Access Compliance Report
Public Rights-of-Way
(Curb Ramps)

Intersection ID: 4861 **Main Street:** HEDGECREST_PL **Cross Street:** MOSSY_BANK_PL **Location:** NE

ADA ID: 7F2393E96399 **Ramp Type:** Perp **Initial Pass/Fail:** Fail **Overall Compliance:** No **Severity Score:** 1.25

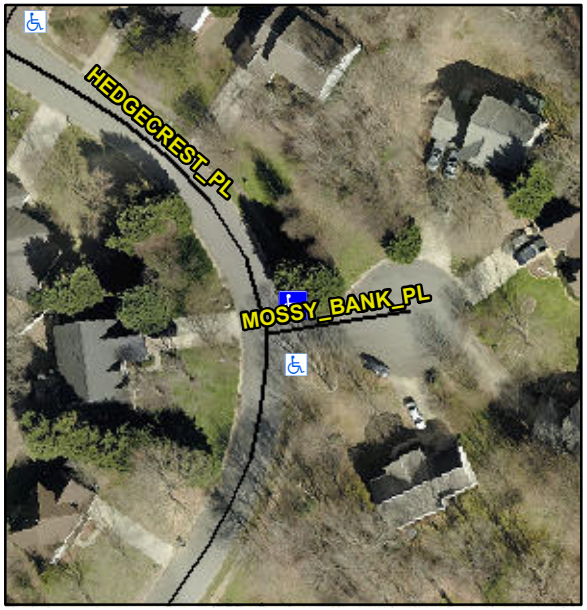
Not Found, R304.5.3

Compliance	Description	Data	Compliance	Description	Data
N/A	Ramp Length (in)	48.0	Yes	Ramp Slope (%)	7.8
Yes	Ramp Width (in)	48.0	No	Ramp XSlope (%)	3.2
N/A	Flare Type LT	N/A	N/A	Flare Type RT	N/A
N/A	Flare Slope LT (%)	N/A	N/A	Flare Slope RT (%)	N/A
N/A	Flare Traversable LT?	N/A	N/A	Flare Traversable RT?	N/A
N/A	Landing Length (in)	N/A	N/A	DWS Provided?	N/A
N/A	Landing Width (in)	N/A	N/A	DWS Contrast?	N/A
N/A	Landing Slope (%)	N/A	N/A	DWS Length (in)	N/A
N/A	Landing X Slope (%)	N/A	N/A	DWS Full Width?	N/A
N/A	Landing Curb? (Y/N)	N/A	N/A	DWS Offset (in)	N/A
N/A	Shared Landing?	N/A			
N/A	Gutter Ponding?	N/A	N/A	Gutter Slope (%)	N/A
N/A	Gutter Lip Ht (in)	N/A	N/A	Gutter X Slope (%)	N/A
N/A	Painted X Walk1?	No	N/A	Painted X Walk2?	N/A
	X Walk 1 Direction	To S		X Walk 2 Direction	N/A
N/A	X Walk 1 Width (in)	N/A	N/A	X Walk 2 Width (in)	N/A
	X Walk 1 Slope (%)	0.8		X Walk 2 Slope (%)	N/A
	X Walk 1 X Slope (%)	6.5		X Walk 2 X Slope (%)	N/A

Remove & Replace Entire Ramp.
